Access Compliance Report

Public Rights-of-Way

(Curb Ramps)

Intersection ID: N/A	Main Street: W_W_T_HARRIS_BV	Cross Street: N/A	Location: NW
ADA ID: 3215F63E0AFB	Ramp Type: Perp	Initial Pass/Fail: Pass	Overall Compliance: No
		Severity Score: 7.75	
Codes/Mitigation Info/Possible Solution		Field Measurements/Component Compliance

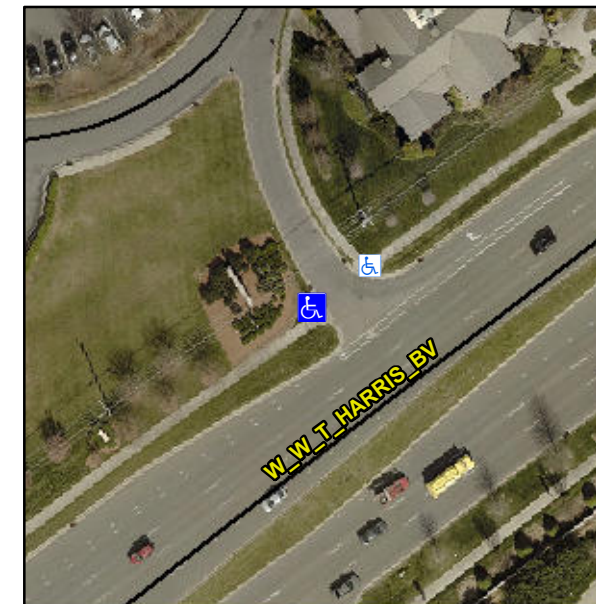
**Remove & Replace Entire Ramp.
Grind Gutter Lip.**

**R304.5.3, R304.2.1, R304.2.2-Perp,
R304.3.2-Para, R302.7.2**
